Stonington

Route 27 – Road Safety Audit

September 28, 2016

AECOM

Figure 3. Crashes that Occurred in 2015 (Connecticut Crash Data Repository)

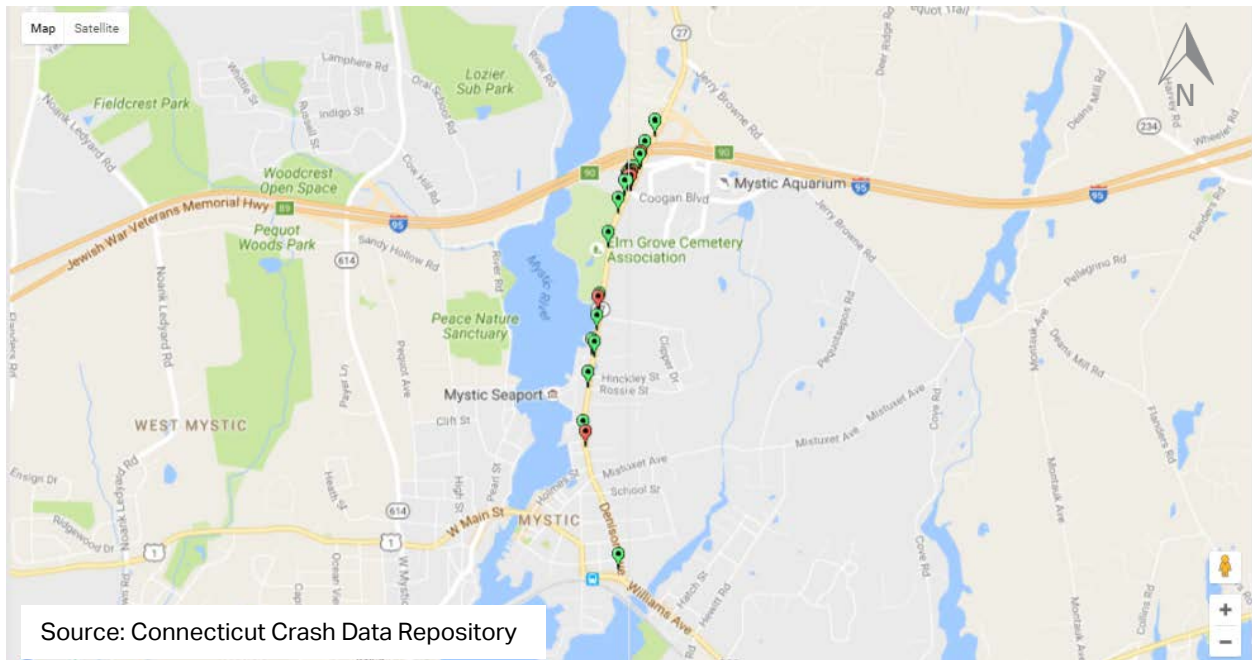
Between 2012 and 2014 there were 113 crashes in the RSA Area. The majority of crashes (79%) reported in this area resulted in property damage only; however 21% of crashes did result in an injury (Table 1 and Table 2). No crashes involved pedestrians or bicyclists. The crash types reported were primarily rear end collisions, turning-intersecting paths, and turning-opposite direction. Figure 3 displays crashes that occurred in this area during 2015. The crash history for year 2015 shows that they are clustered around intersections.

Figure 4. Old Post Road/Tolland Stage Road Geometrics

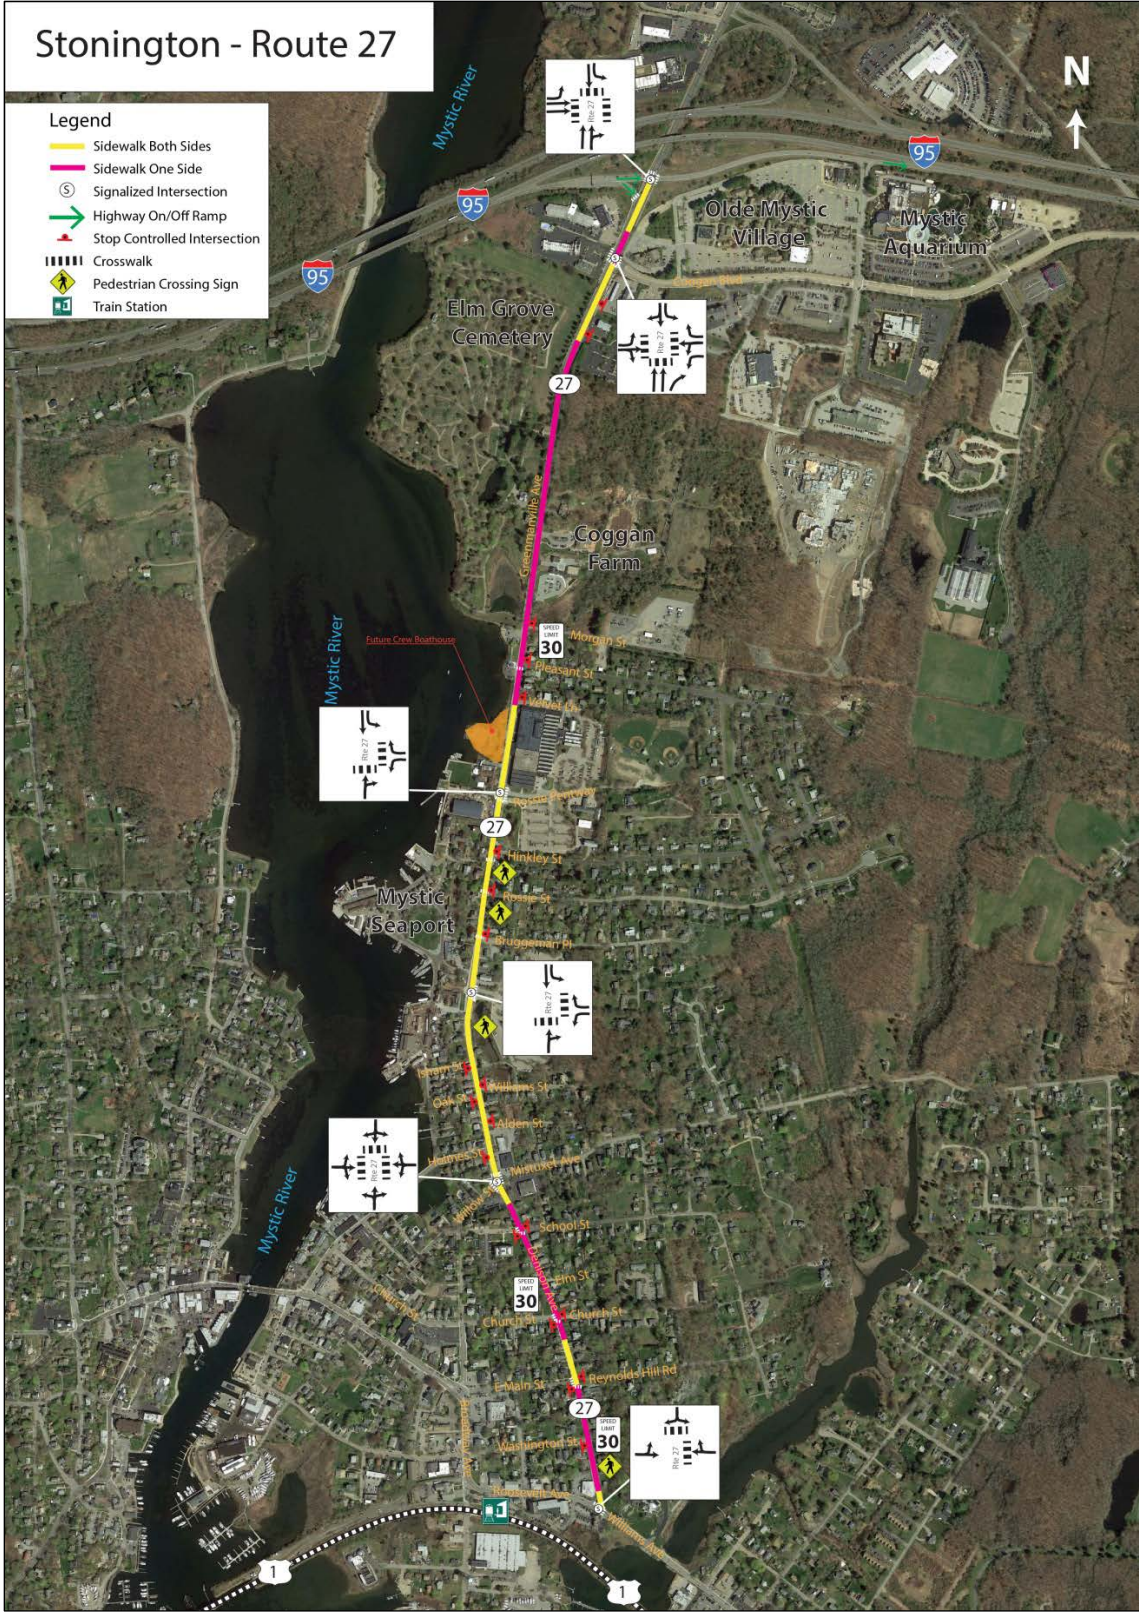
Route 27 is a two lane, state owned road with a speed limit of 30 mph. There are six signalized intersections and numerous stop controlled intersections within the 1.7 mile study corridor (Figure 4). All six signalized intersections have crosswalks across two or more legs. Sidewalk exists along the entire corridor on the west side of the road, but is intermittent on the east side. There are seven midblock crosswalks within the corridor. The road is striped with a double yellow centerline to separate the northbound and southbound flows of traffic, and there are shoulder lines on both sides for the entire length. Table 3 is a summary of the roadway conditions throughout the RSA area.

Figure 37. Short Term Recommendations

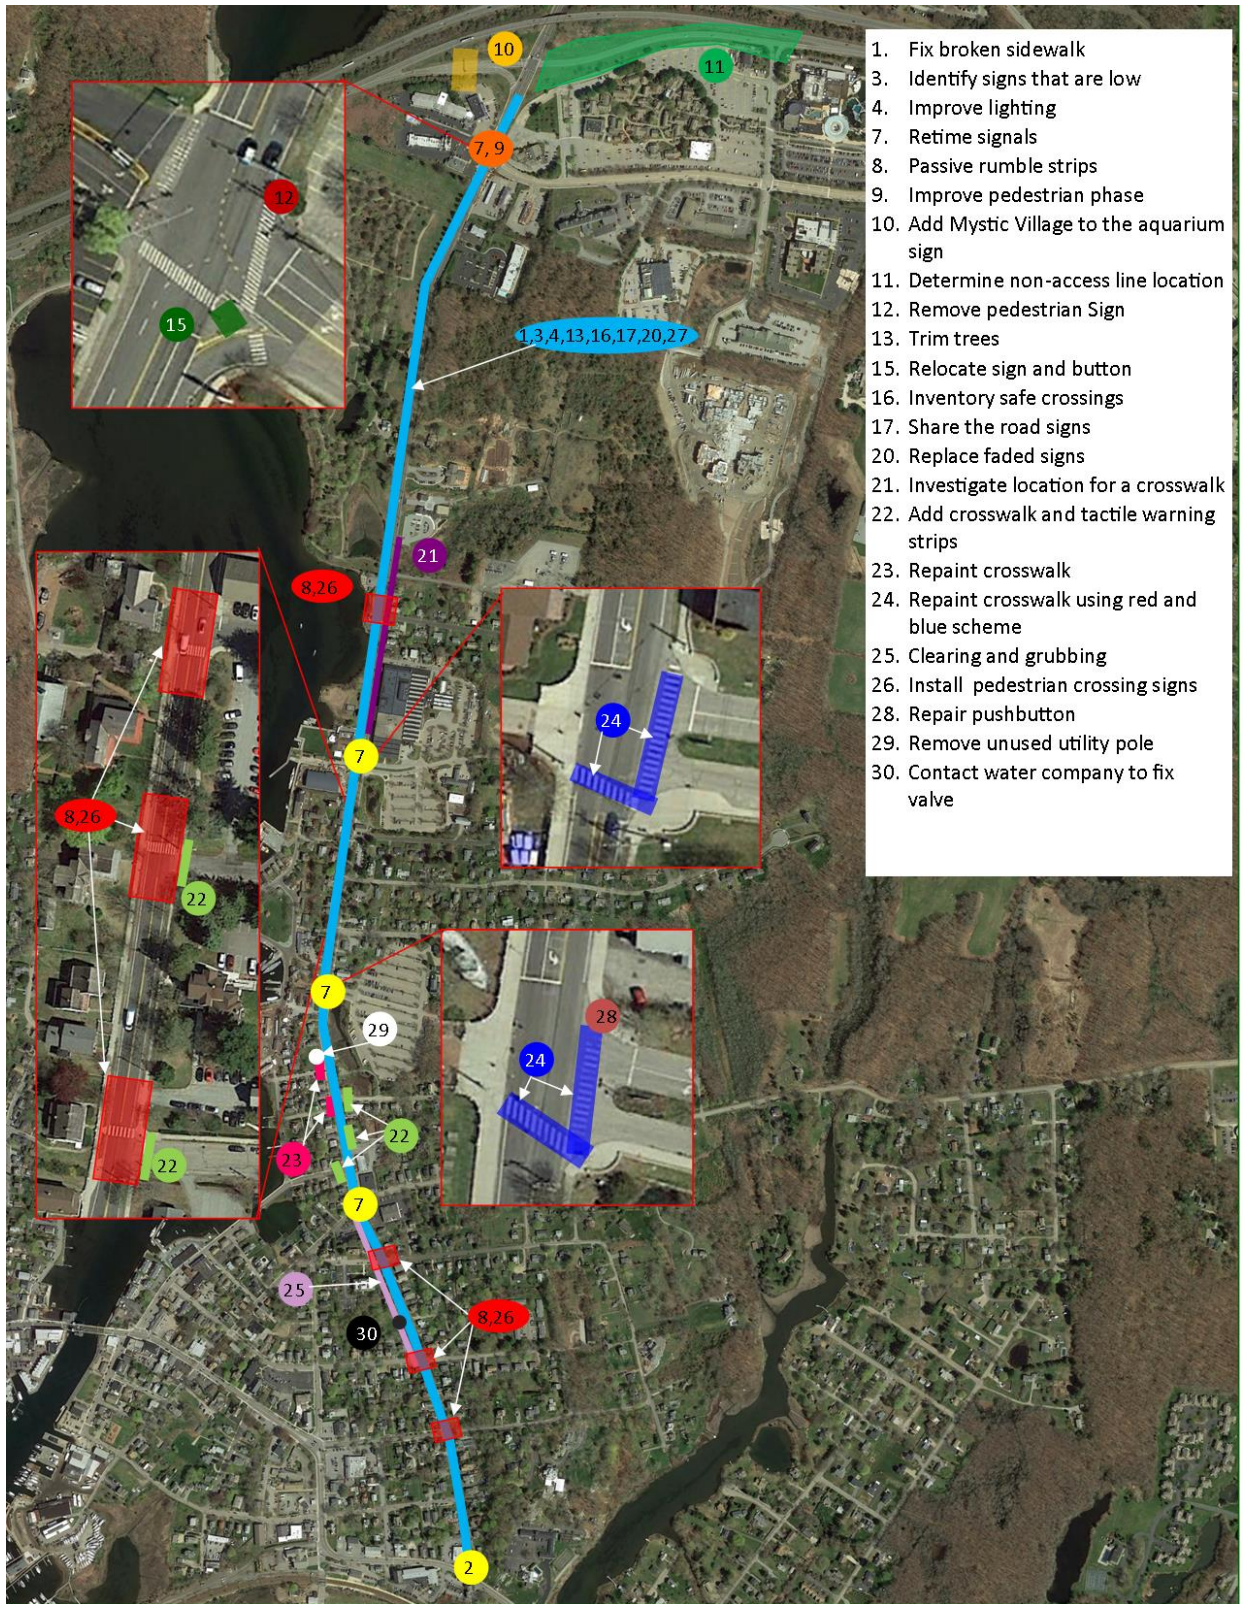
1. Fix broken sidewalk sections.
2. Evaluate local roads for the appropriateness of signing for no buses.
3. The Town to coordinate with the CTDOT to identify signs that are too low and raise them.
4. Contact Eversource to improve overhead lighting on crosswalks by installing LED bulbs and adjusting light shed (Figure 31).

5. The Town to coordinate with the CTDOT to put up active speed signs. A letter from The Seaport should be submitted in support of this.
6. The Town to coordinate with the CTDOT district office to determine where Route 27 is on the list to upgrade pedestrian amenities at all signals.

7. Retime signals to meet new standards for pedestrian crossing time.
8. Examine passive rumble strips across the road on the approaches to mid-block crossings (Figure 32).

9. Investigate the Coogan Boulevard signal to see if there is a better way to incorporate the pedestrian phase.
10. Add Mystic Village to the Aquarium sign.

11. Determine where the non-access line is on Delcore Drive.
12. Remove the pedestrian sign behind the utility poles in the northeast corner of the Coogan Boulevard and Route 27 Intersection.

13. Trim trees blocking signs along Route 27.
14. Create a mailing to educate property owners on sidewalk maintenance.
15. Relocate the sign and pedestrian push button on the pole in the channelizing island at Coogan Boulevard and Route 27 to indicate the correct crossing.

16. Inventory locations for safe crossings along Route 27.
17. Install share the road signs (Figure 33).
18. Create maps that highlight bike friendly routes and points of interest for tourists.

20. Replace faded and worn-out signs that are not retroreflective.
21. Investigate where the best location for a crosswalk is between Coogan Farm and the north Seaport parking lot.

22. Add a crosswalk across and ADA ramps with tactile warnings strips at Bruggeman Place, Rossie Street, Alden Street, Williams Street, Holmes Street.
23. Repaint the side street crosswalks at Isham Street and Oak Streets and the western one at Coogan Boulevard.

24. The Town to coordinate with the CTDOT to repaint the crosswalks at the signalized intersections for the Seaport parking lots to stand out more using a red and blue striping scheme (Figure 34).

25. Perform clearing and grubbing on the asphalt section of the sidewalk.
26. Install advanced warning signs for all pedestrian mid-block crossings (Figure 35).

27. Contact homeowners to trim vegetation encroaching on the sidewalk (Figure 36).
28. Repair the broken pushbutton in the northeast corner of the Route 27 and southern parking lot entrance.

29. Remove the unused telephone pole in the northeast corner of Isham Street and Route 27.
30. Contact the water company to repair the water valve with a missing cover.

Figure 42. Mid Term Recommendations

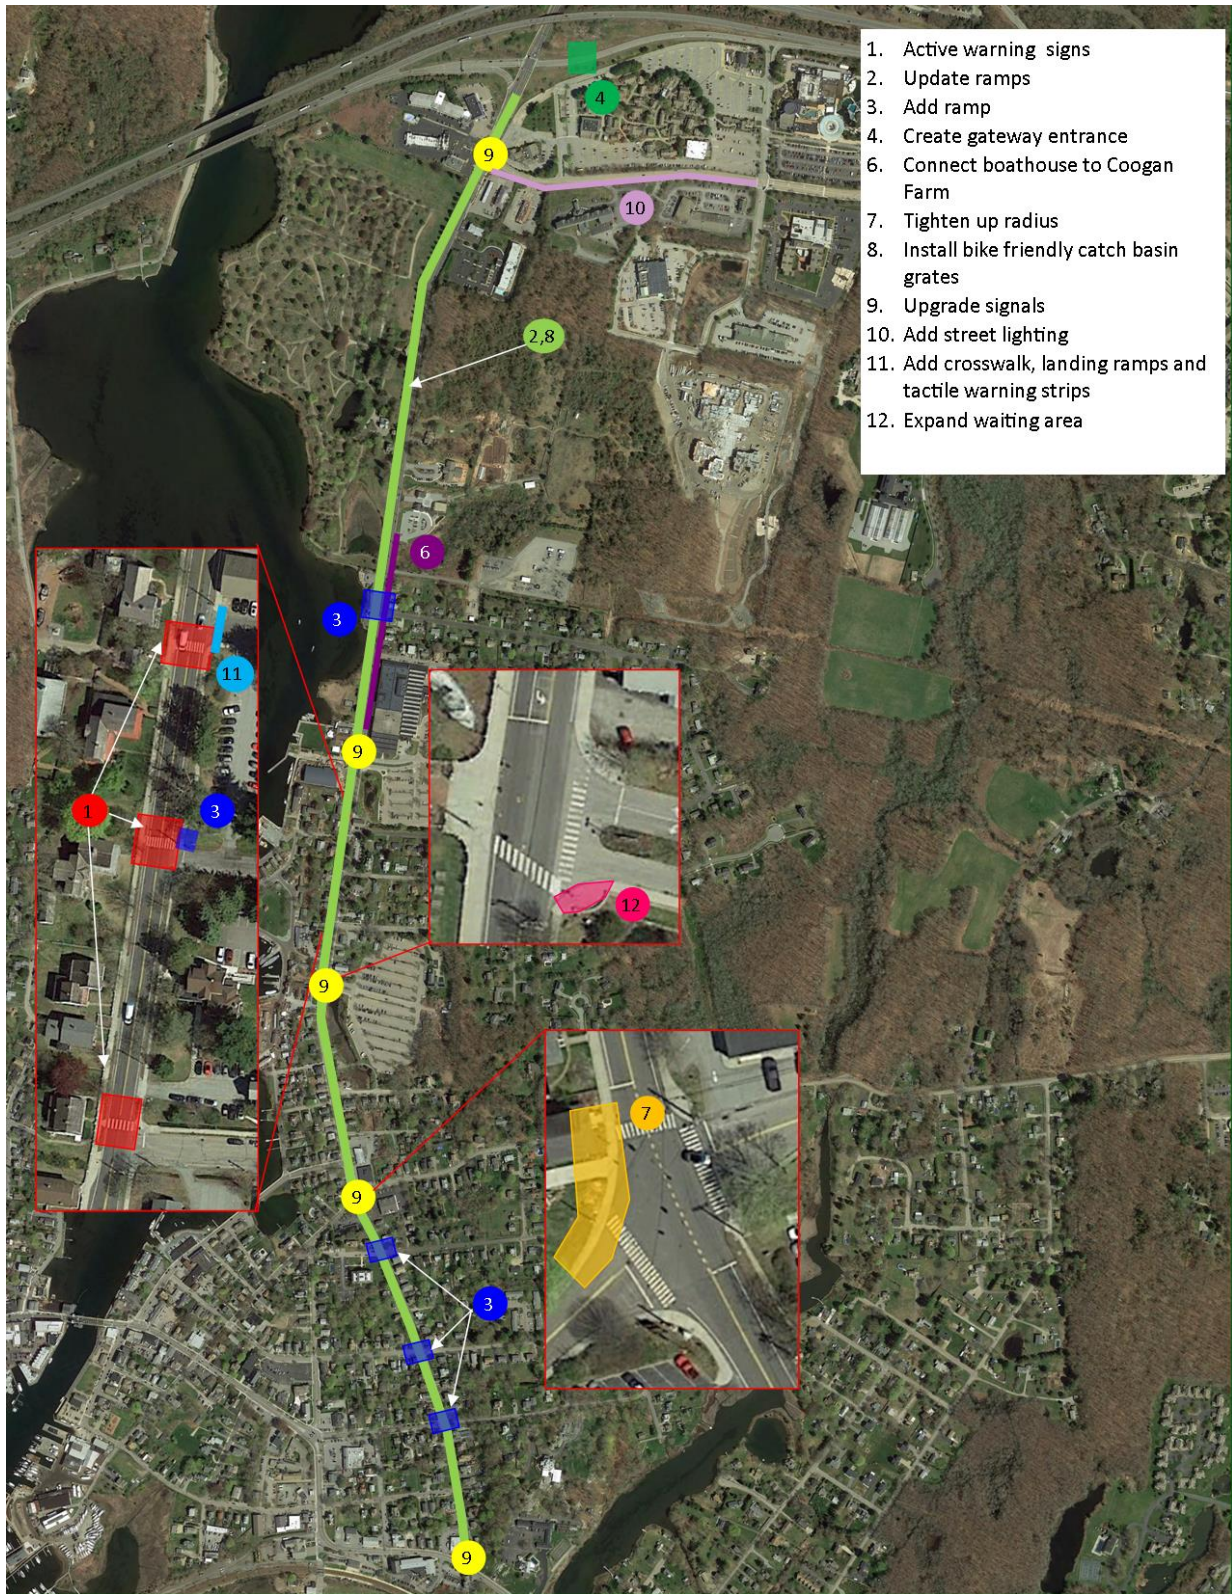
1. Install active warning systems at the three unsignalized crosswalks in front of the seaport (Figure 38).
2. Update all ramps to be ADA compliant with tactile warning strips (Figure 39).

3. Add ramps to all crosswalks where missing.
4. Create a gateway entrance to Aquarium that encourages motorists to use Delcore Drive.
5. Implement the findings from the safe crossing inventory by adding, relocating or eliminating mid-block crosswalks.

6. Determine the best way to connect the new boathouse to Coogan Farm.
7. Tighten up the northeast radius at the Willow Street intersection in order to shorten the crosswalk and remove the driveway from the middle of the intersection.

8. Install bicycle friendly catch basins grates (Figure 40).
9. Upgrade all signals to have countdown heads and push buttons to be ADA compliant with audible and tactile directional arrows (Figure 41),

10. Add street lighting along Coogan Boulevard and the intersection with Route 27
11. Add a crosswalk, landing ramps, and tactile warning strips across Hinckley Street.

12. Expand the landing/waiting area in the southeast corner at the signal for the southern parking lot.
13. Extend the sidewalk on the east side, which ends 200 feet to the north of Coogan Boulevard to the intersection.

1. Active warning signs
2. Update ramps
3. Add ramp
4. Create gateway entrance
6. Connect boathouse to Coogan Farm
7. Tighten up radius
8. Install bike friendly catch basin grates
9. Upgrade signals
10. Add street lighting
11. Add crosswalk, landing ramps and tactile warning strips
12. Expand waiting area

Figure 43. Long Term Recommendations

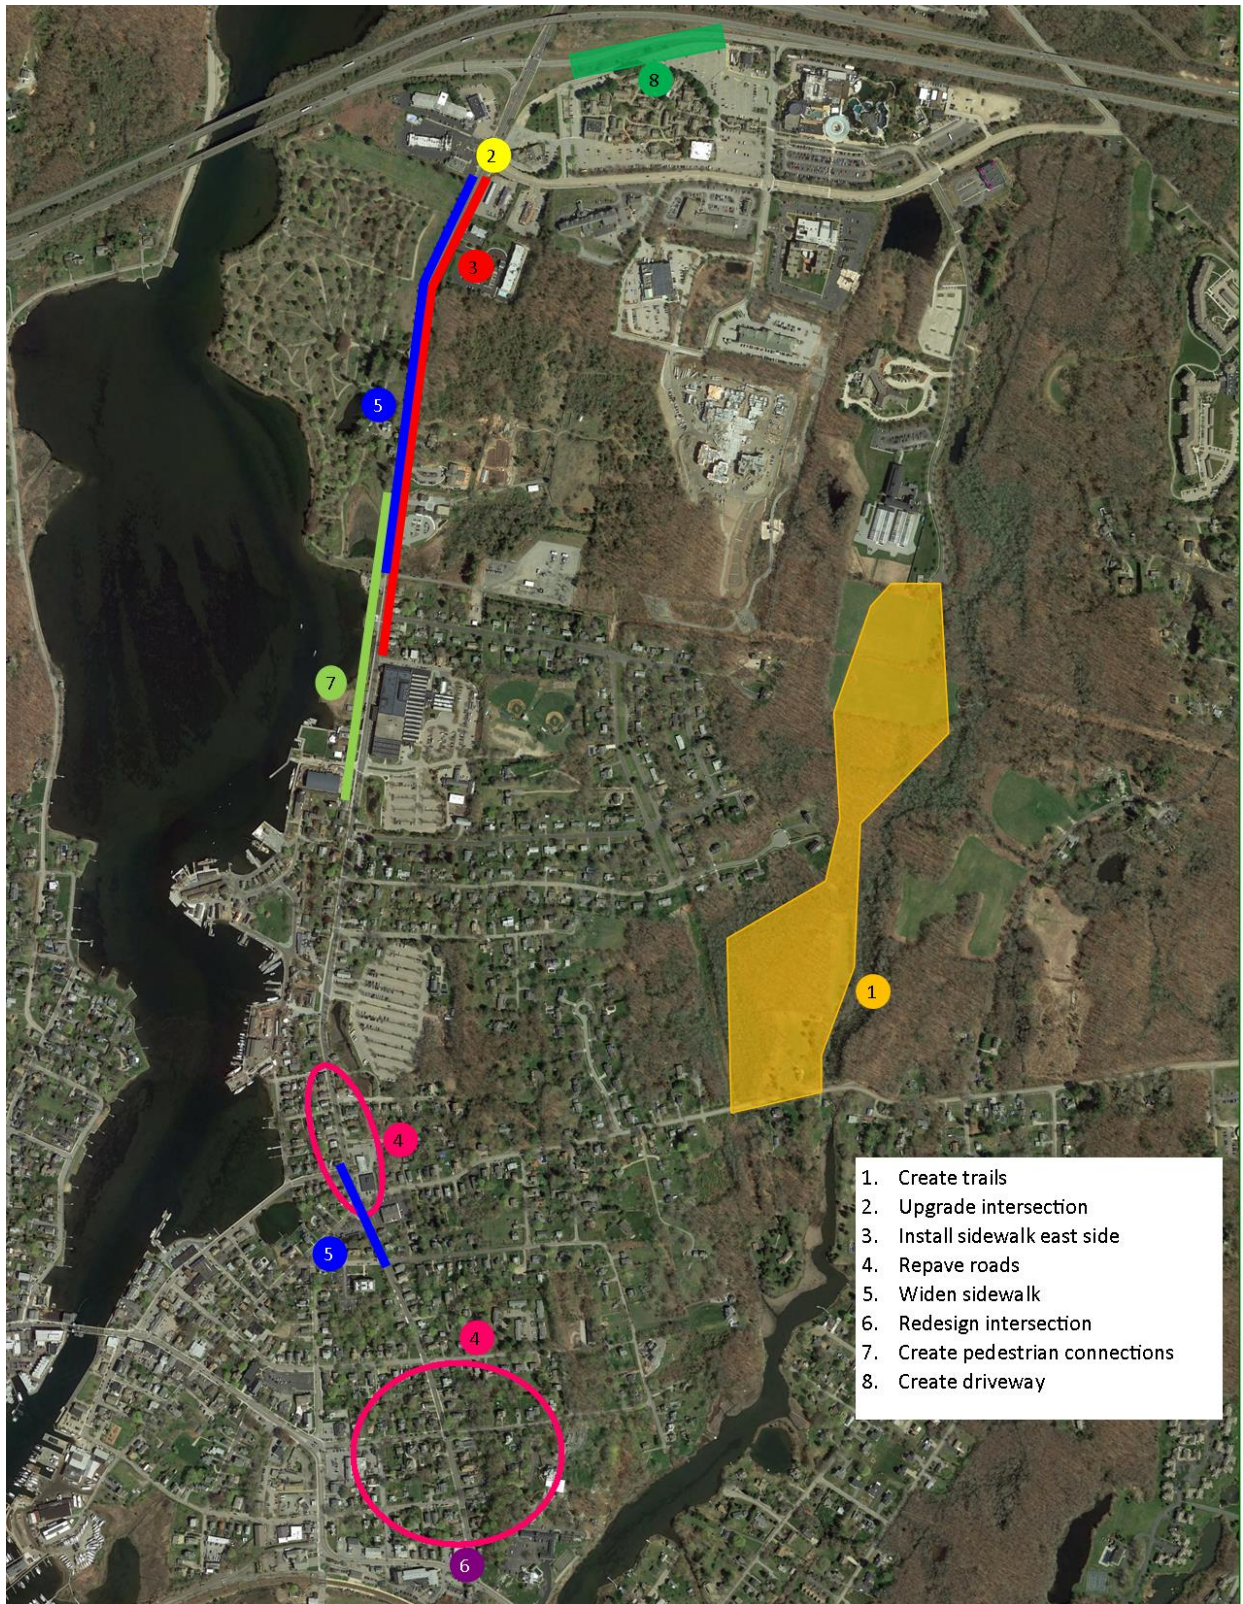
1. Create multiuse trails from Maritime Drive connecting to the Seaport with a greenway to Mistuxet Avenue and Coogan Boulevard. If needed to traverse wetlands install a boardwalk.
2. Upgrade the Coogan Boulevard signal with ramps, a safer refuge island, crosswalks across all legs, and pedestrian signal heads.
3. Install a sidewalk along the east side of Route 27 from The Hyatt to Velvet Lane.
4. Repave the intersecting local roads south of The Seaport.
5. Widen the sidewalk between Willow Street, Church Street, Coogan Boulevard, and Morgan Street to a minimum of five feet and concrete.
6. Redesign the Route 1 and Route 27 intersection to shorten the crossing, expand the sidewalk and improve flow per the Mystic Mobility Study.
7. Create safe pedestrian connections between The Seaport, boathouse, and Coogan Farm.
8. Create driveway access from Delcore Drive to Old Mystic Village.
